The PTO's for Nissan and Iveco Daily having electromagnetic shift have been modified quite significantly. The assembly magnet/piston is now located opposite to the PTO output shaft. The advantages of this modification are:

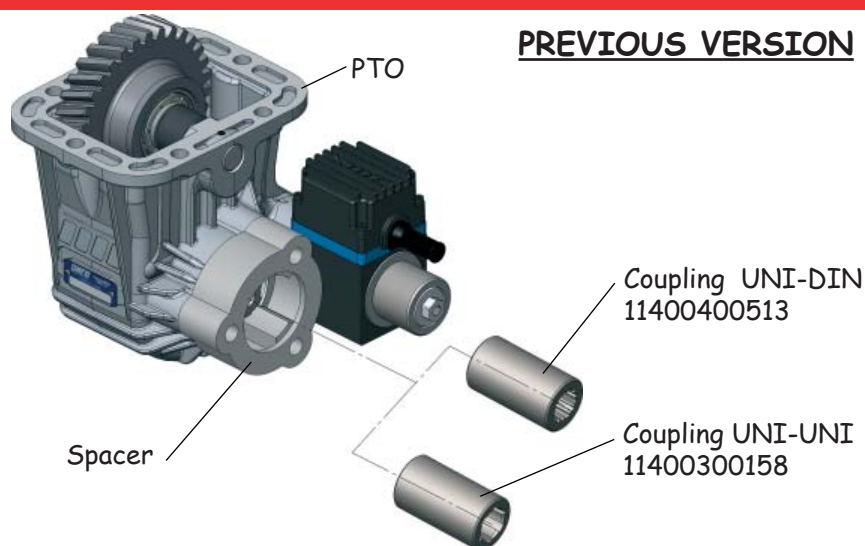
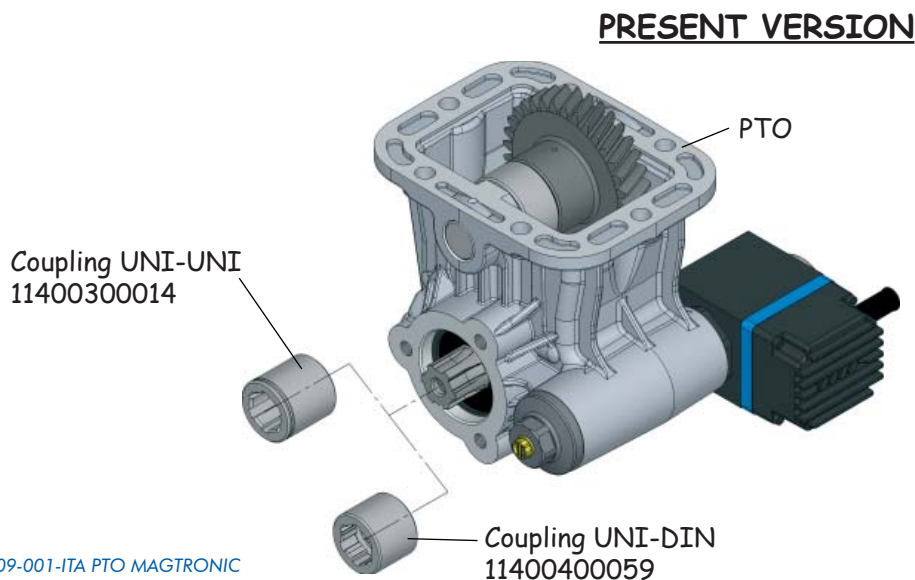
- Spacer for mounting the pump no longer required.
- Use of standard couplings L=30mm instead of special ones L=62mm.
- Possibility to take out the magnet without removing the pump.

The modification is shown in the following picture while in the chart you can find the new part numbers. Magnets and electric harnesses of both old and new PTO versions are fully interchangeable.
